RE: Loft at 1801

1801 Mesa Vista Rd. NE Grading & Drainage Plan

Hydrology File: J15D103

Based upon the information provided in your submittal received 06/09/2023, the Grading & Drainage Plans are approved for Building Permit, Grading Permit, and SO-19 Permit. Please attach a copy of this approved plan in the construction sets for Building Permit processing along with a copy of this letter.

DRAINAGE MANAGEMENT PLAN

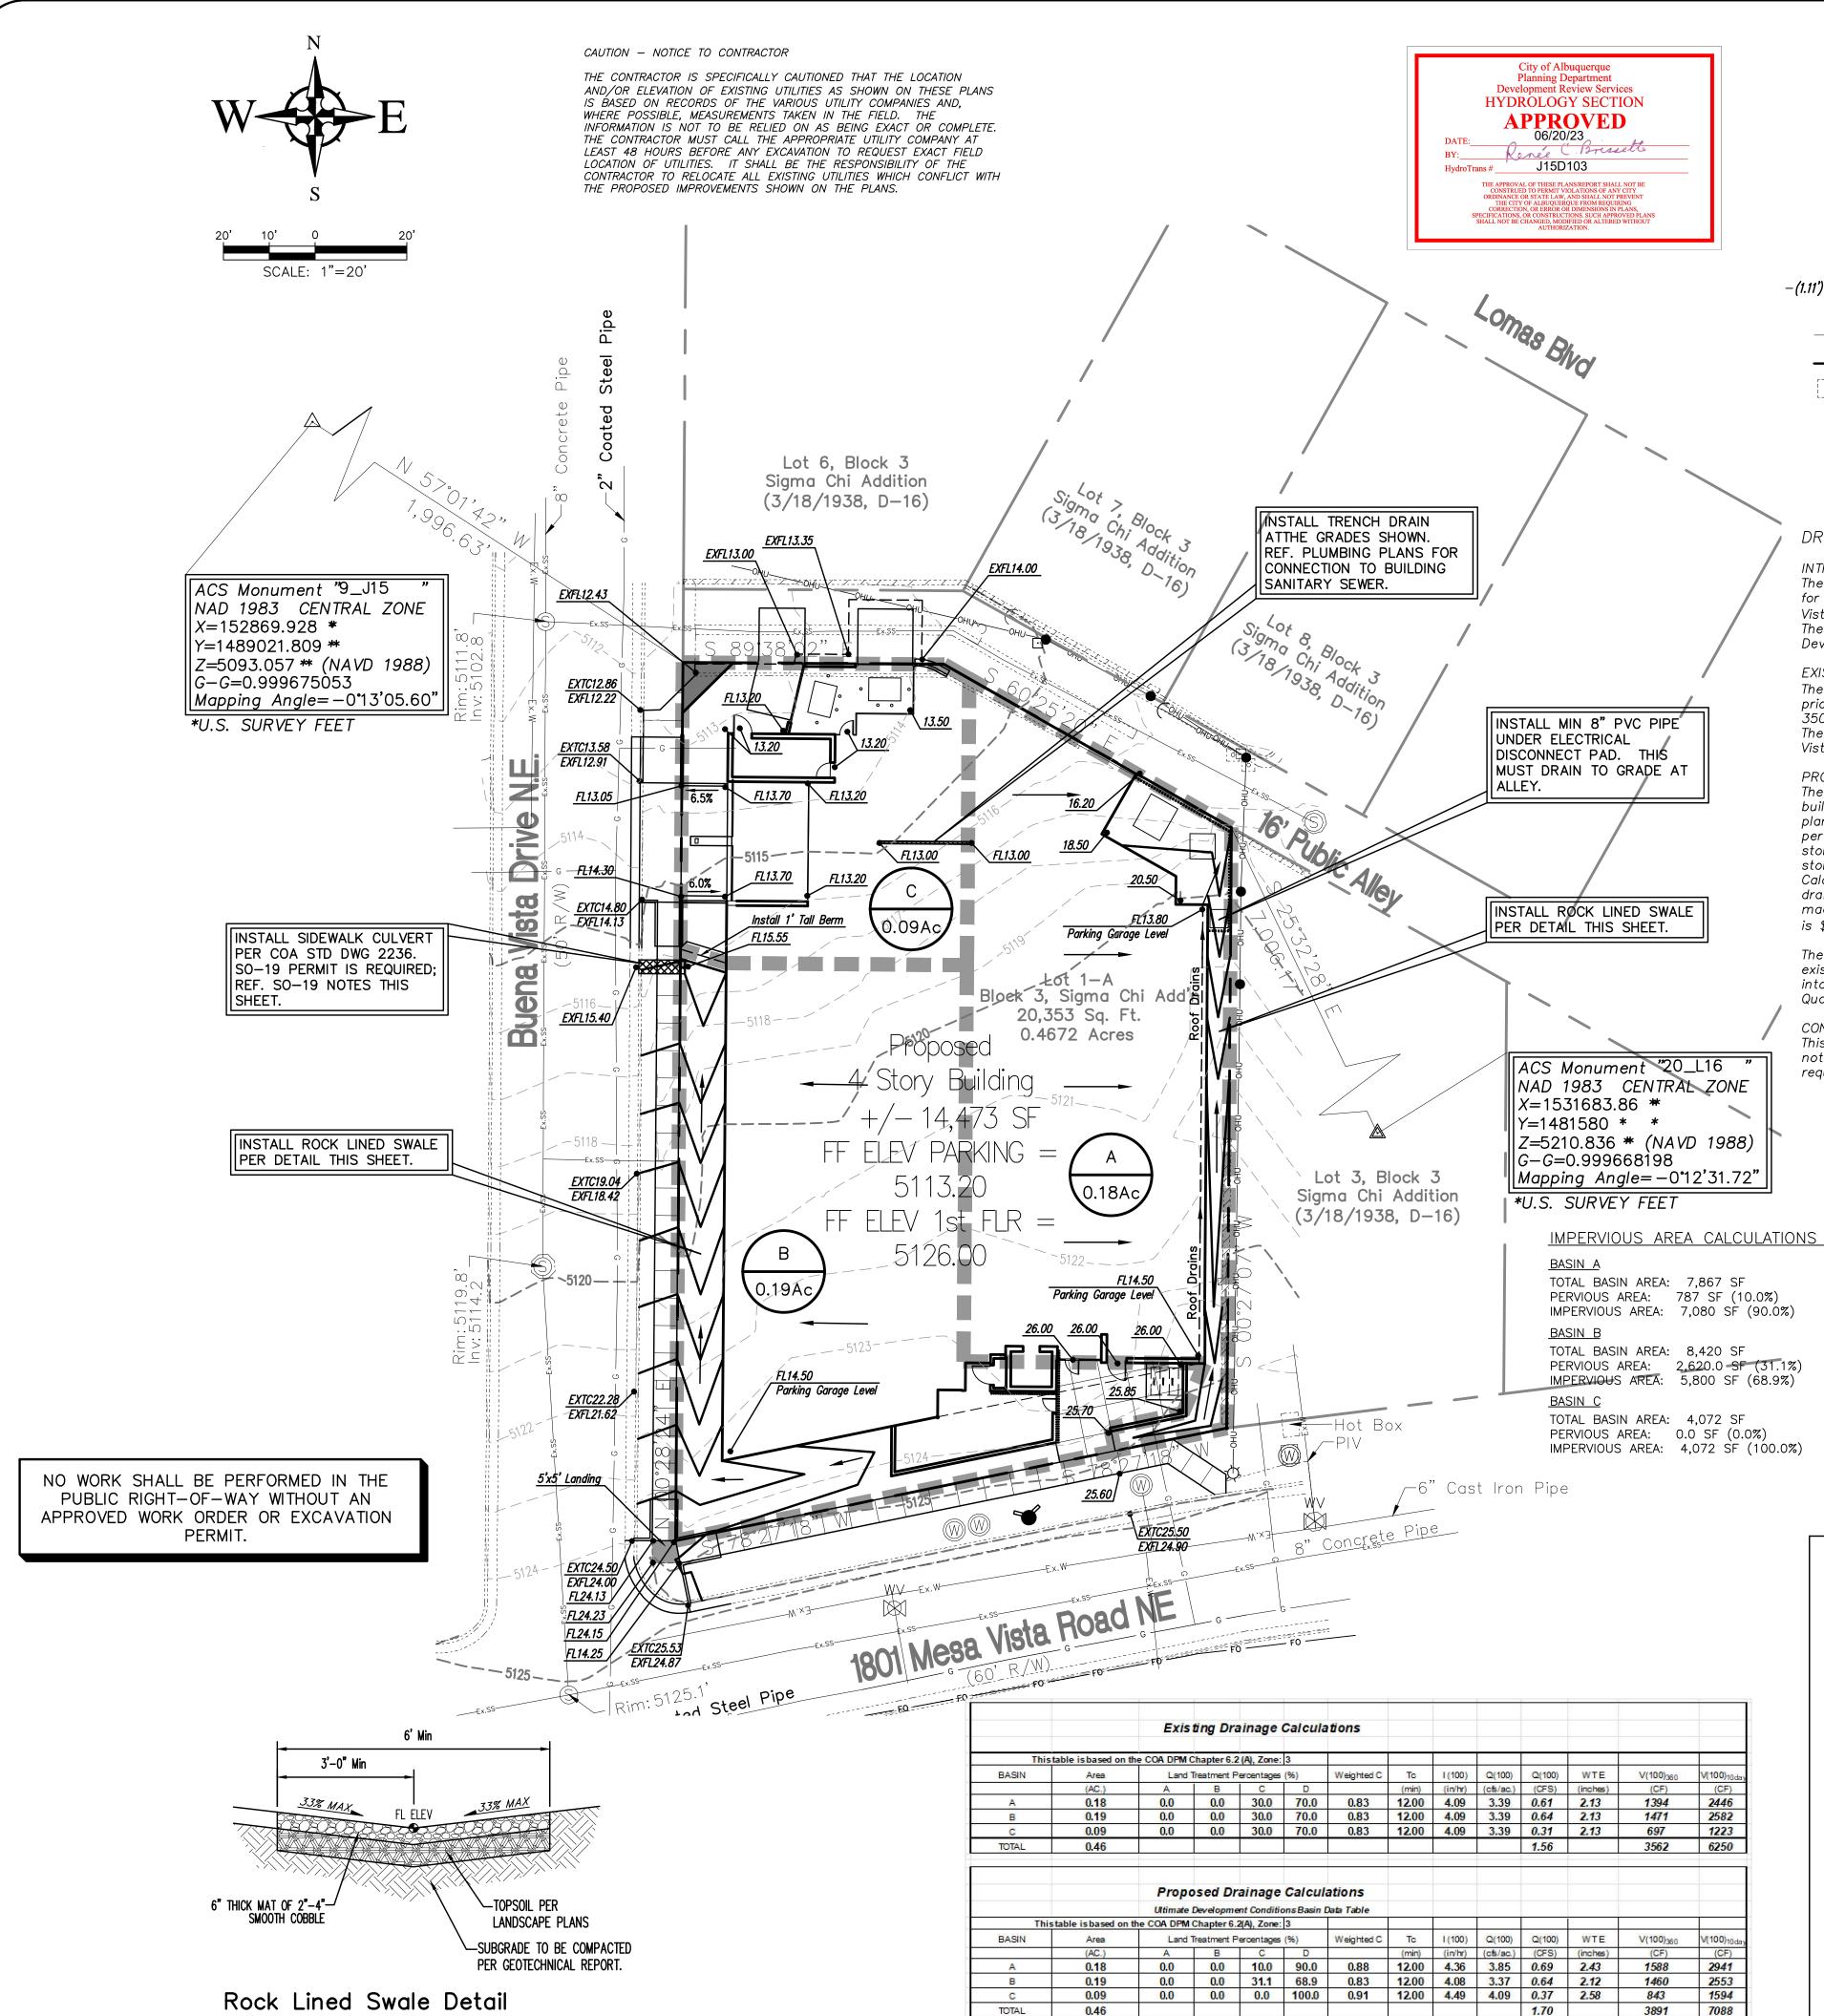
1. Engineer's Certification, per the DPM Part 6-14 (F): *Engineer's Certification Checklist For Non-Subdivision* is required.

- 2. Please provide the executed paper Drainage Covenant (latest revision) printed on one-side only with Exhibit A and a check for \$25.00 made out to "Bernalillo County" for the stormwater quality ponds per Article 6-15(C) of the DPM to Hydrology for review at Plaza de Sol.
- 3. Please pay the Payment-in-Lieu of \$ 704.00 by emailing the attached approved Waiver Application from Stormwater Quality Volume Management On-site to PLNDRS@cabg.gov. Once this is received, a receipt will then produce and email back. Follow the instructions on the bottom of the form and pay it at the Treasury next to Building Permits. Once paid, please email me proof of payment.
